From: Catriona Mackenzie <cat@urbanforestryaustralia.com.au>
Sent: Tuesday, 29 May 2012 7:30 AM
To: David Gazzoli
Cc: Ryan Fury
Subject: Further information.

Re – Trimming of tree H18:158

**Practice Fairway
Grading Plan**

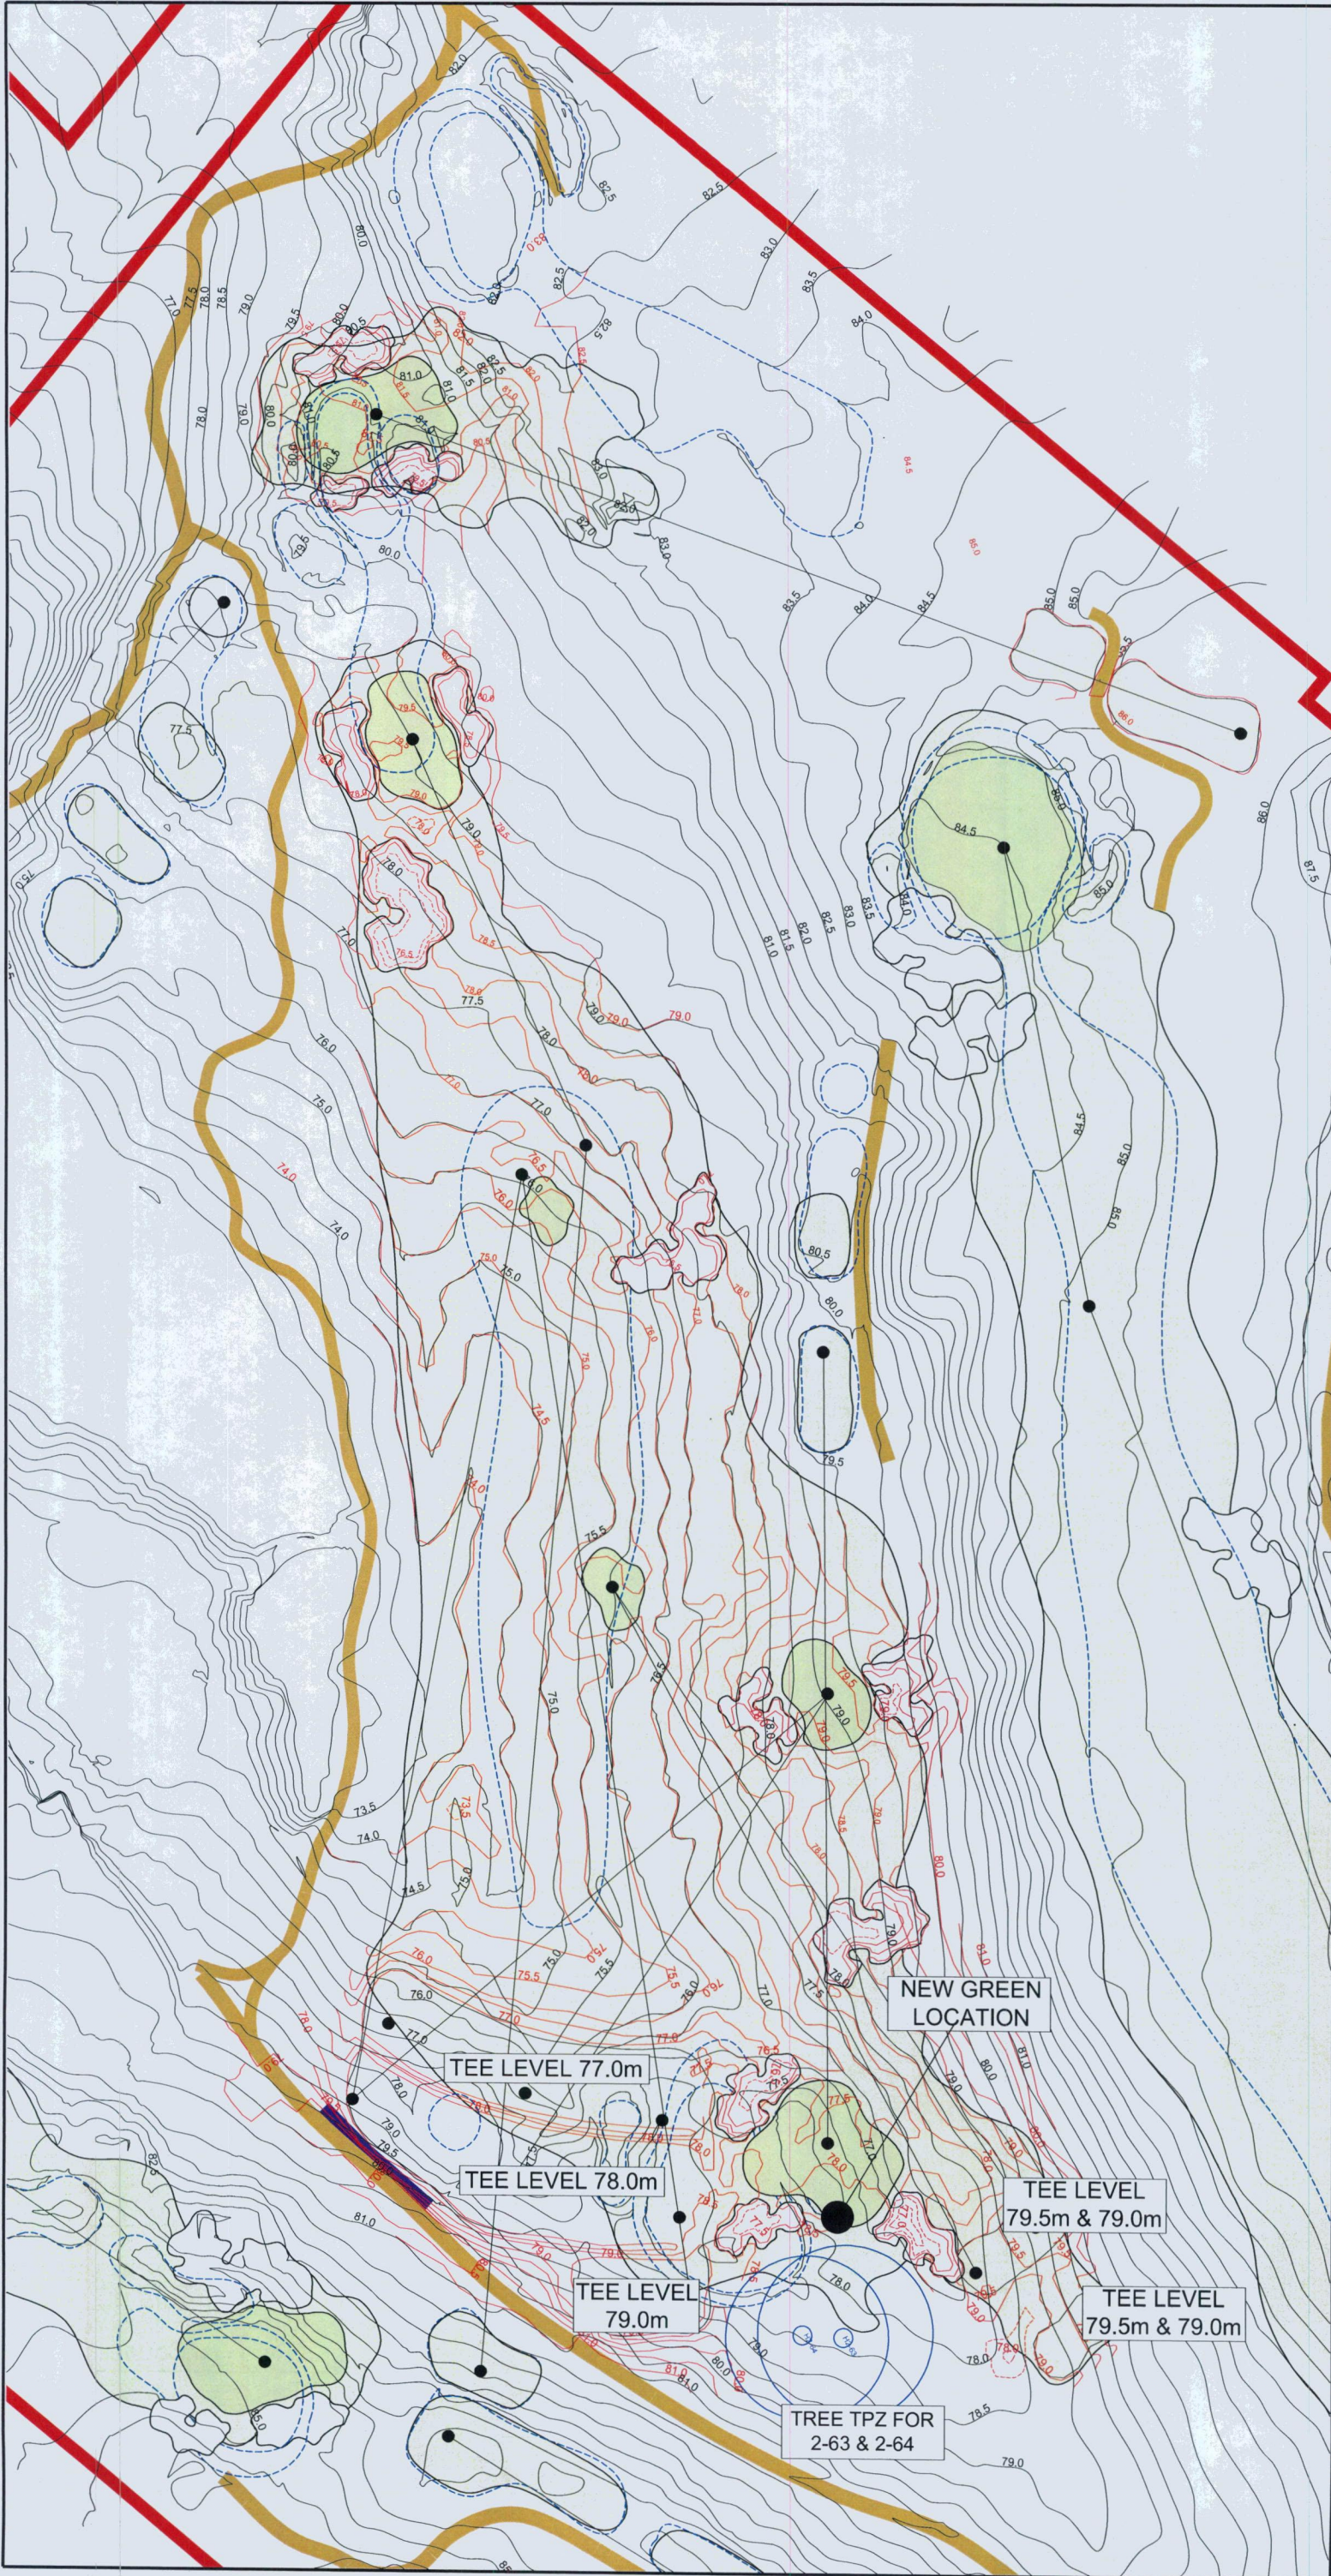
- H18-158 – My main concern with this tree is the evidence pointing to the likely existence of an internal column of decay in the trunk - from the cavity in the southside lower trunk, the depressed vertical section arising from this cavity area and extending up to the decayed trunk section to the southwest side of the stem. The presence of extensive reaction wood to the east side of the lower stem indicates the tree has grown this area to 'shore up' a weakened stem. The large scaffold branches and crown above the stem appear to be sound, although my concern is with the weight of these parts bearing down on a structurally weakened trunk. This feature is akin to placing a heavy brick on top of a section of hosepipe – there is considerable risk of the stem buckling under the weight of the parts above it.
The extent of decay and its impact on stem wood strength can be measured by diagnostic decay testing (e.g. Resistograph® or Sonic Tomograph testing), although it needs to be understood this testing does not treat the disease and only provides information to determine whether the tree must be removed entirely or can be retained for a specified period and subject to routine re-testing, pruning, etc.

Given the obvious extent of decay affecting the lower stem right up to the top of the stem, it is my opinion diagnostic testing is not warranted and that substantial removal of the crown is the only way to remove the weight on this weakened stem. It is the tree's poor condition and location that increases the risk to the golf club's staff and players, and that despite any testing, the tree needs to undergo some reduction of the weight above the obviously compromised stem.
The tree should have the crown reduced at, or within 1m of the stem bifurcation to significantly reduce the weight issue. Any subsequent re-growth should be managed according to arboricultural assessment and advice.

Following the recent resubmission of additional documentation for the Killara Golf club D.A. 0147/11 the landscape officer requested some additional clarification on four trees and the landscape planting plans in an email dated 24th May 2012. This letter relates to tree H18: 158 and is to be viewed in conjunction with the Arborist, Catriona Mackenzie's updated information dated Tuesday 29th May 2012 which is attached. Below is the photo of the tree and the crown reduction while maintaining the trunk with any cavities as fauna habitat.
